## SERVICE BULLETIN

INCORPORATION OF SPACER AT OIL - QUANTITY TRANSMITTER MOUNT - CATEGORY CODE 4 -  
MOD.ENG-79-0017

V2500-ENG-79-0017

Oil Quantity Transmitter  
Fig.1

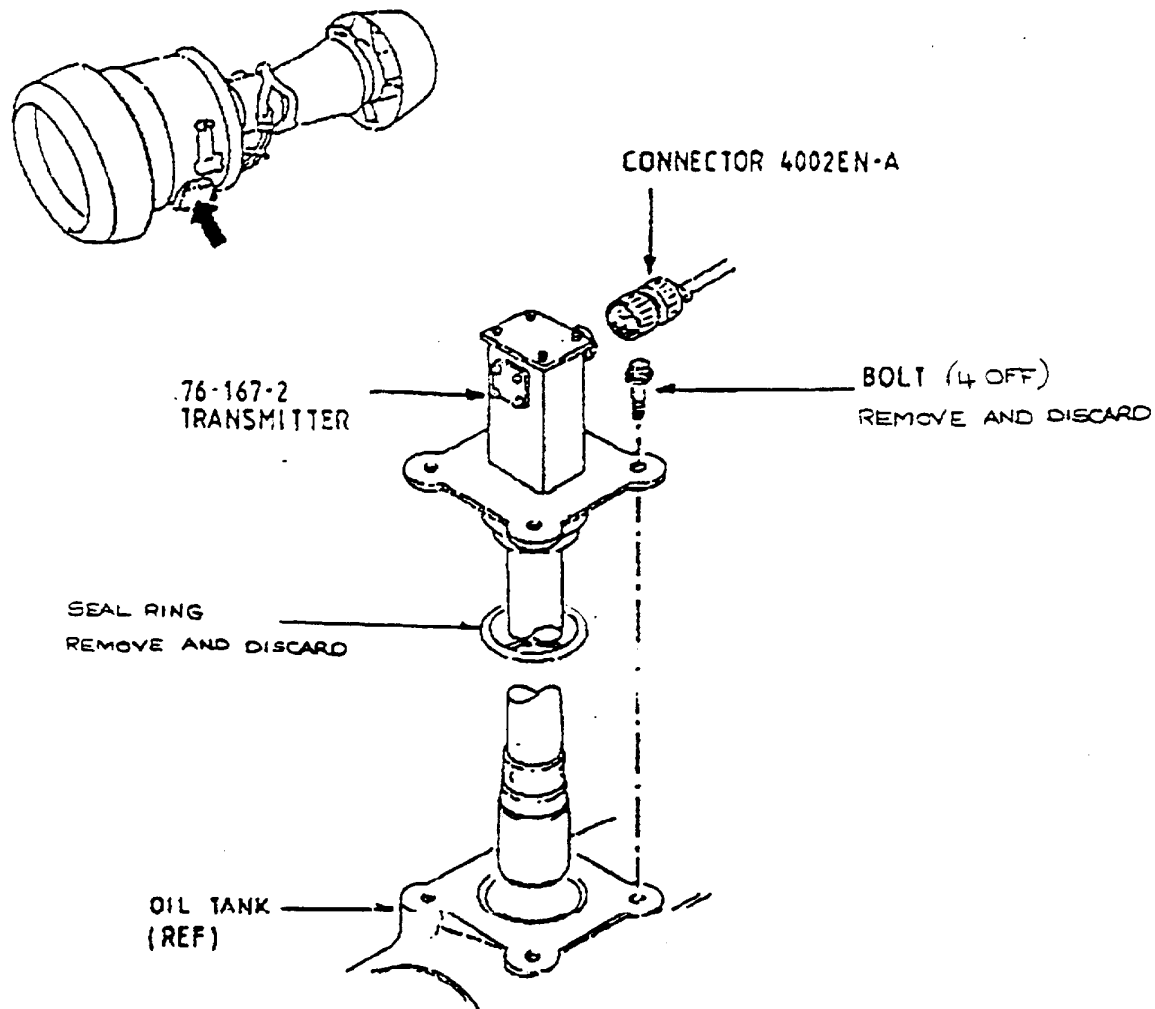
This Service Bulletin (modification) introduces a spacer and an additional seal ring between the oil quantity transmitter and the oil tank to reduce the risk of contact of the transmitter with the oil tank base.

- A. Open the fan cowl doors as specified in the Aircraft Maintenance Manual, Task 71-13-00-010-010.
- B. Add the spacer and seal ring to the oil quantity transmitter assembly as follows:
- (1) Remove the connector 4002EN-A from the oil quantity transmitter. Remove the four (4) bolts securing the oil quantity transmitter to the oil tank and remove the oil quantity transmitter Part No. 76 167-2. (See Figure 1.)
  - (2) Remove the seal ring from the oil quantity transmitter and replace with a new seal ring as supplied.
  - (3) Re-assemble the unit by fitting the seal ring AS43013-151 and spacer 740 5140-501 to the top face on the oil tank. Replace the transmitter assembly and secure the assembly with the four (4) new bolts supplied (AS 21515). Replace the connector 4002EN-A.
  - (4) Close the fan cowl doors as specified in the Aircraft Maintenance Manual, Task 71-13-00-410-010.
